RAPPORT DE MISSION

Subject: South Sudan WASH RSO Mission (*refugee's part of the mission*)
Auteur: Jerome BURLLOT (WASH Adviser/RSO Nairobi)
Date: Du 31th August au 4th September 2015

Flow rate evolving along a day to get the same daily production according source of energy used

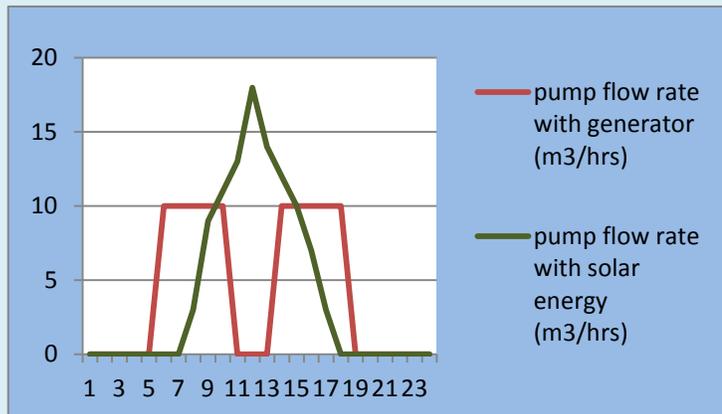
<p>Note: The table here below show what would be typical difference between selecting a pump working with solar energy and selection a pump working with generator to get the same daily water production. As you can see the pump working with is not pumping at the same flow rate full day, it pump much more at noon as the direct sunlight is higher than at 3pm or 10am for instance. The pump working with generator is pumping at a fix rate all day long. In consequence, the pump to be selected to get the same daily quantity of water</p>

should pump much more quantity of water during few times around noon and the BH yield should be able to match this flow rate during enough time. Then the BH yield has to be much higher than the BH yield for a pump working with generator. The pump working with solar should be 18m³/hrs at max for short time when the one working with generator will be 10m³/hrs, same for the yield of the BH.
